Contract Number DAAK11-84-D-0016
Task Number 39

Rocky Mountain Arsenal

Offpost Remedial Investigation/Feasibility Study

Final Technical Plan
July 1988

Figure 1.1-1
LOCATION MAP

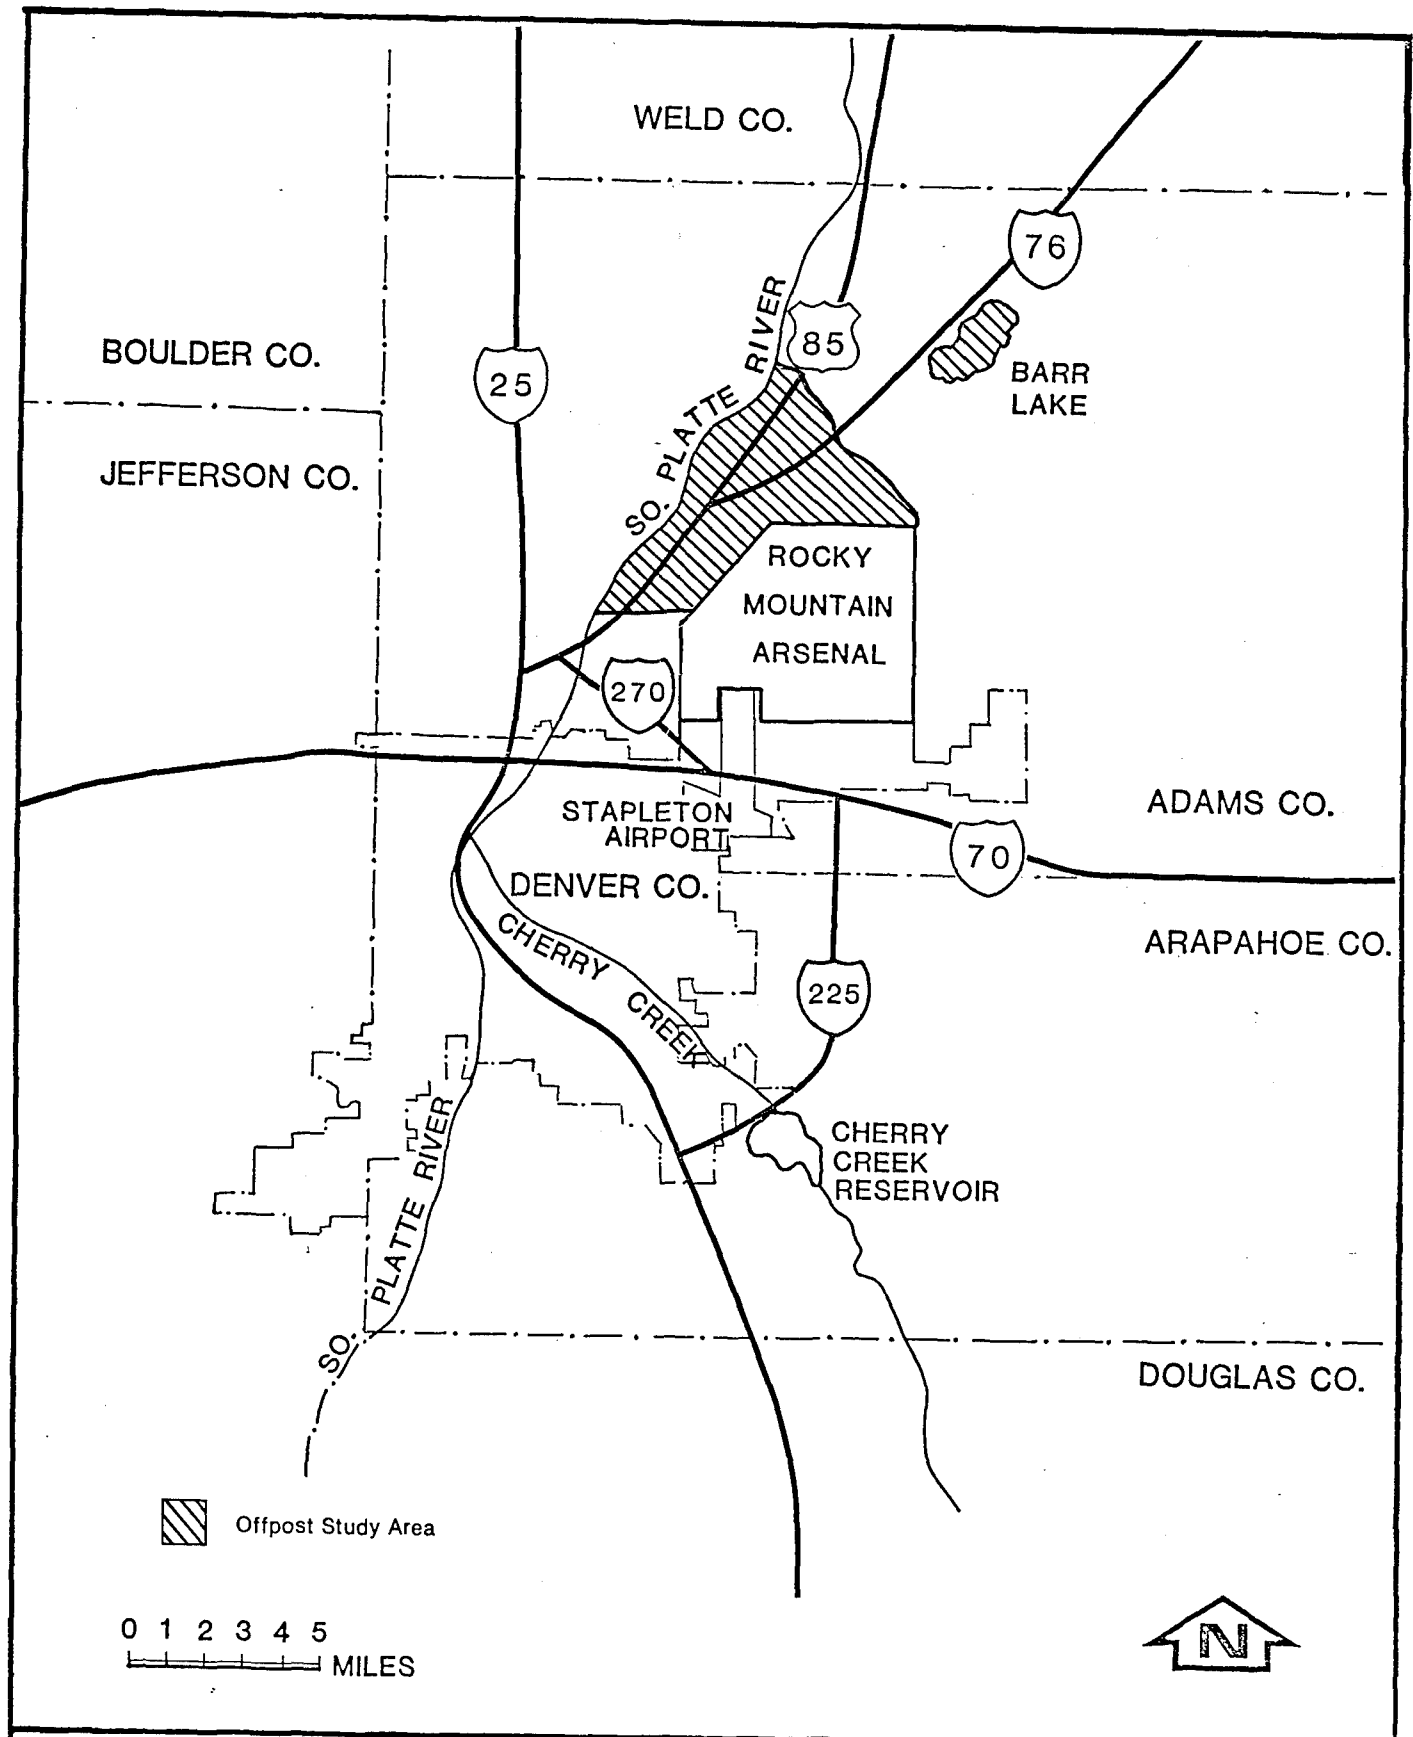
Comment 2: The Off-Post RI study area should be shown for reference Page 1-5, to regional features to supplement Figure 1.3-1. Figure 1.1-1

Response: The offpost study area will be shown on Figure 1.1-1 in the Final Technical Plan.

Figure 1.3-1
OFFPOST STUDY AREA

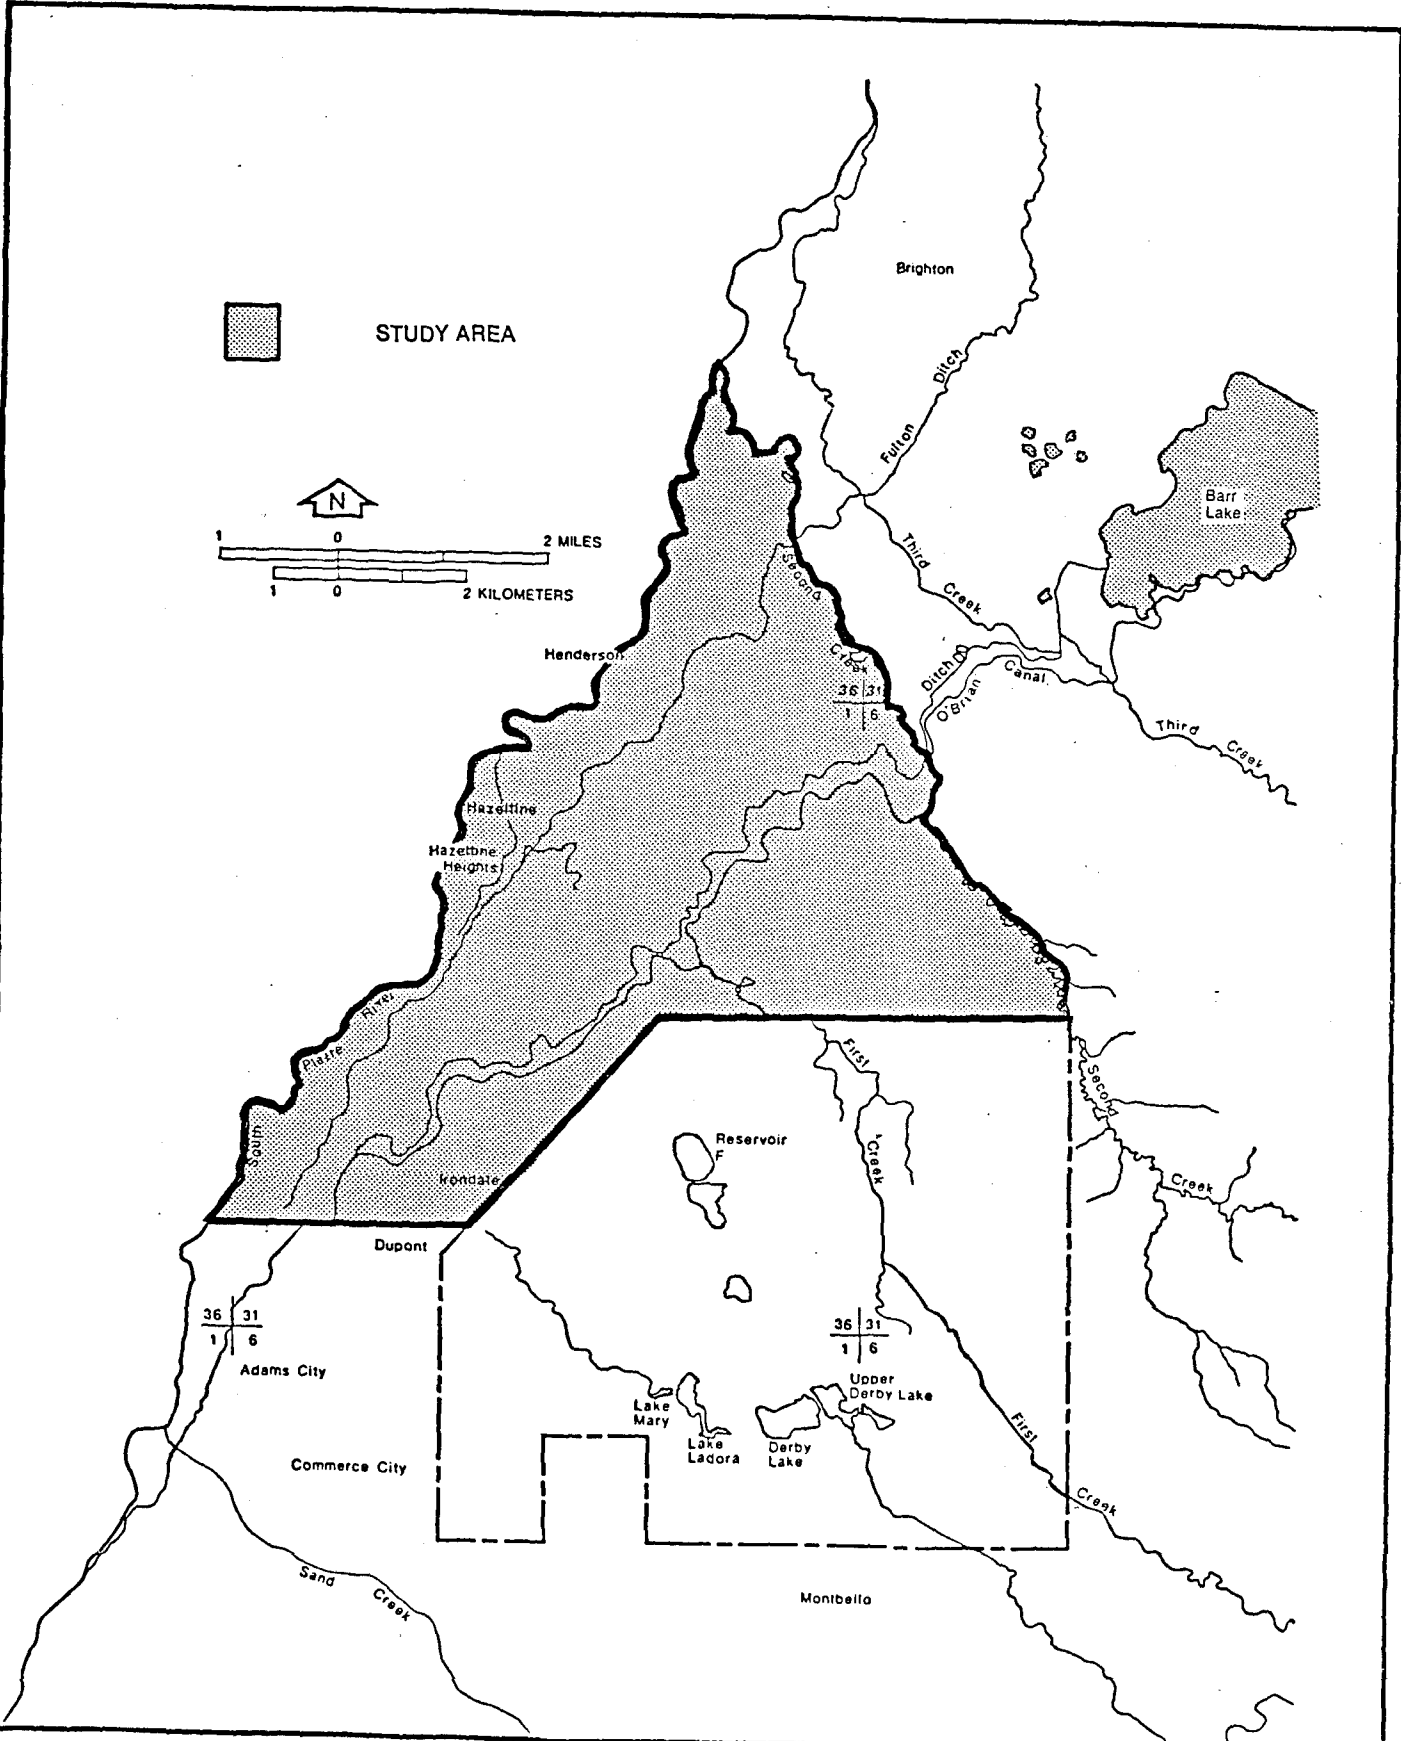
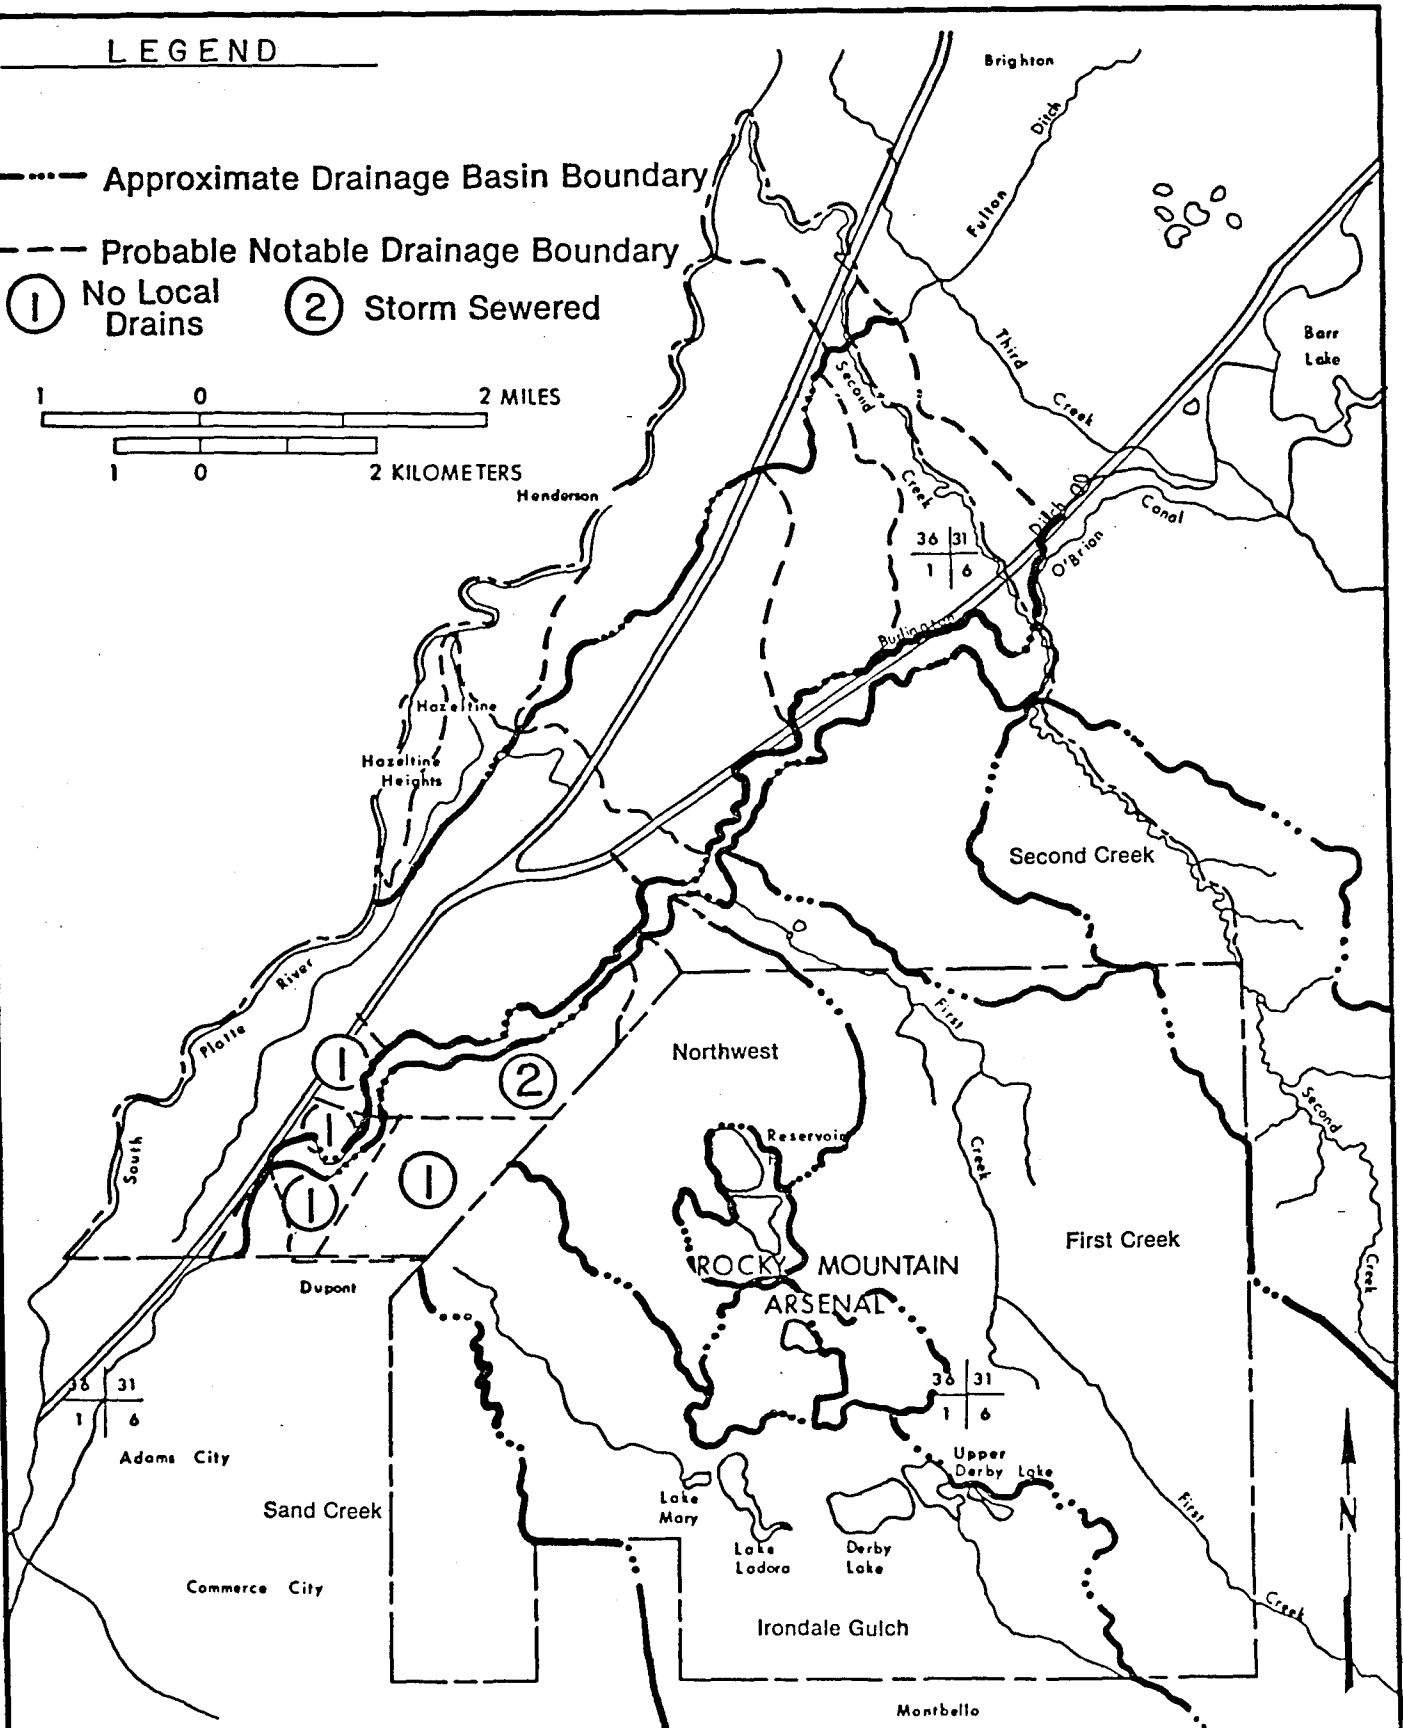
Comment 4: The text indicates that the O'Brian Canal and Burlington Ditch intersect Second Creek. Yet Figures 1.3-1 and 1.3-2 indicate that Second Creek continues to the South Platte River.
Page 1-11,
Top of Page

Figure 1.3-7
ELEVATIONS OF BEDROCK SURFACE

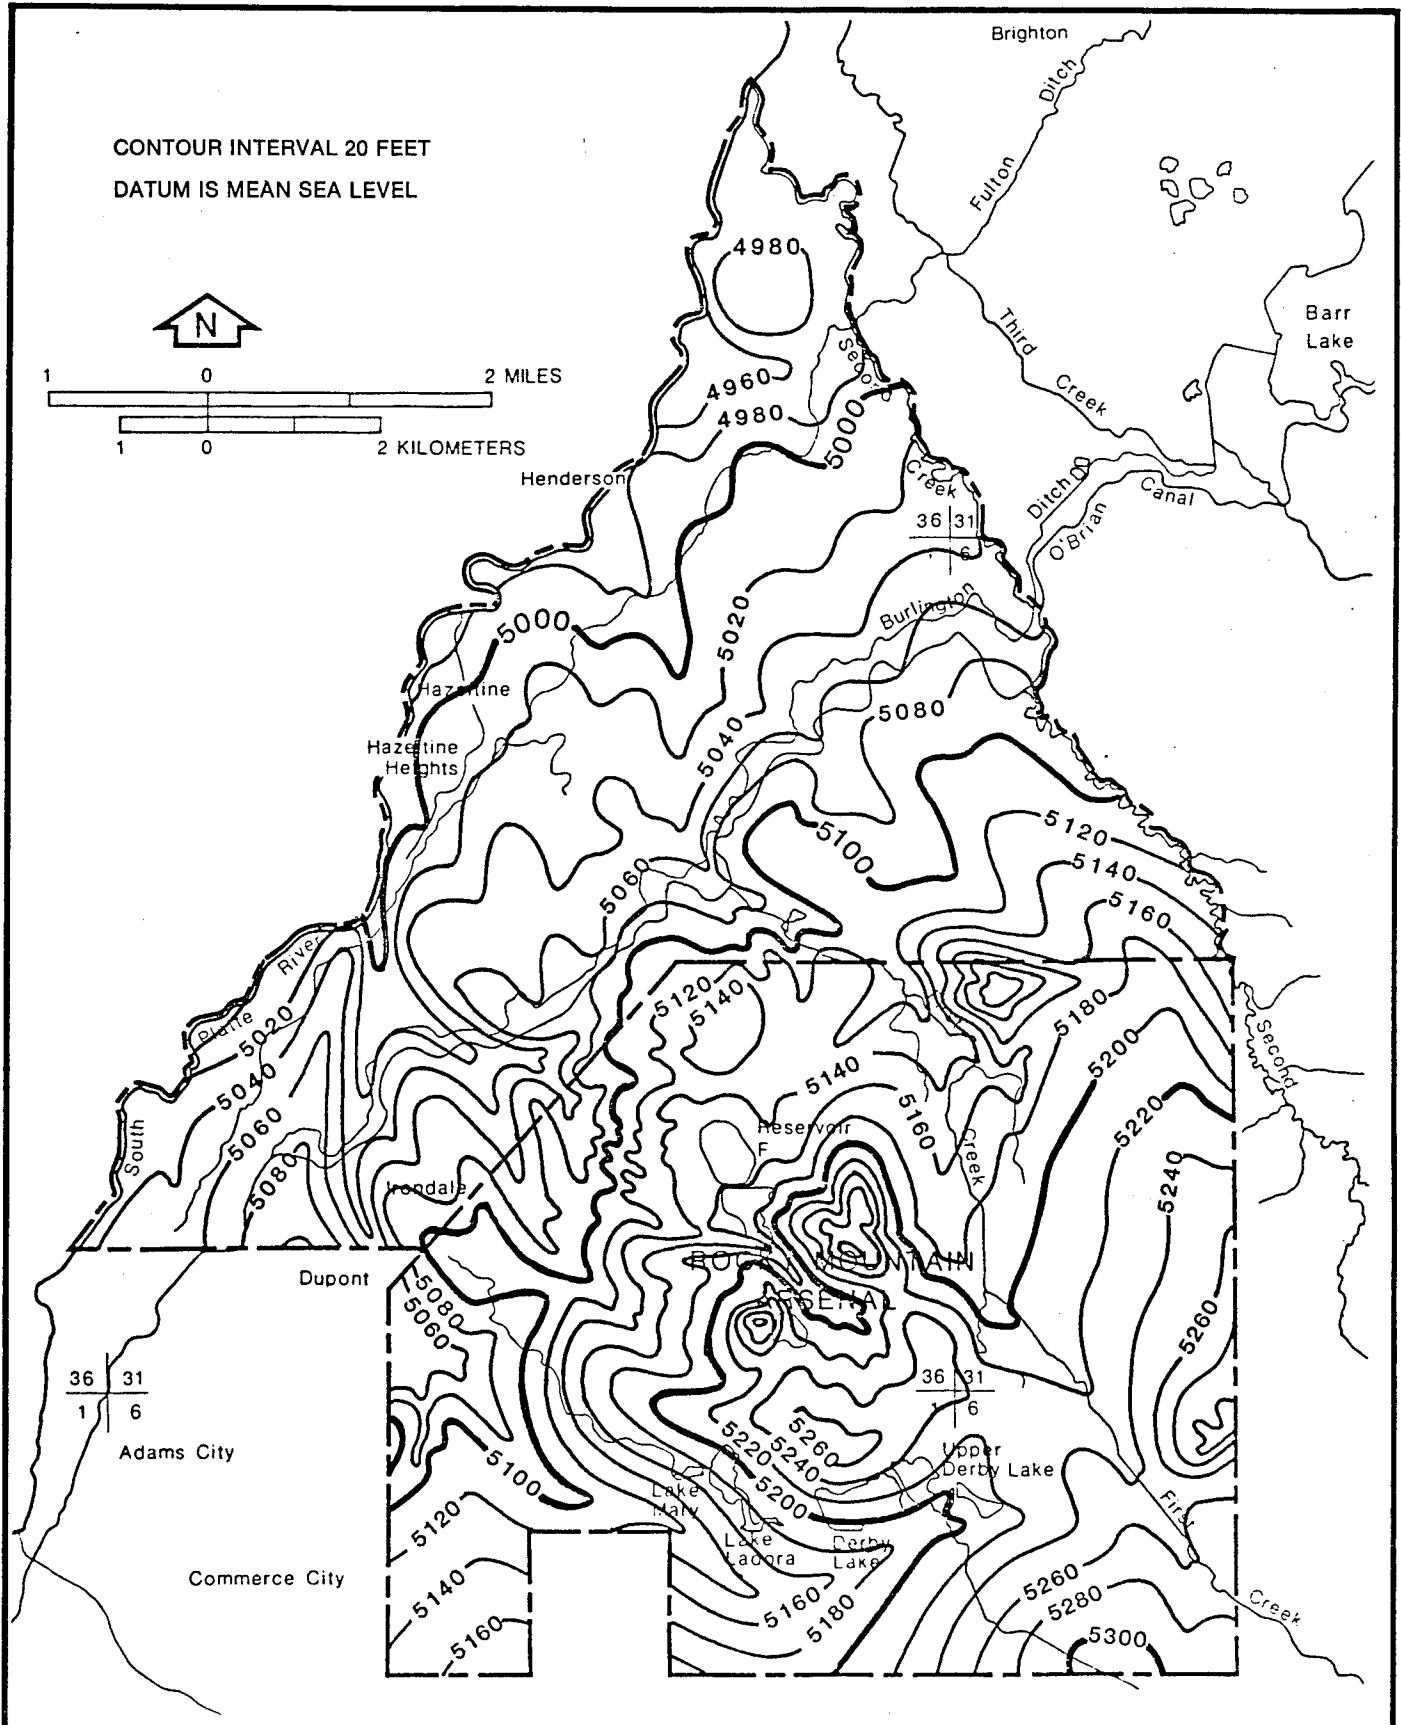
The text and Figure 1.3-7 should indicate that elevations of bedrock surface are "preliminary" drawings or estimates of the orientation of paleochannel depressions because they are based on a limited amount of data.
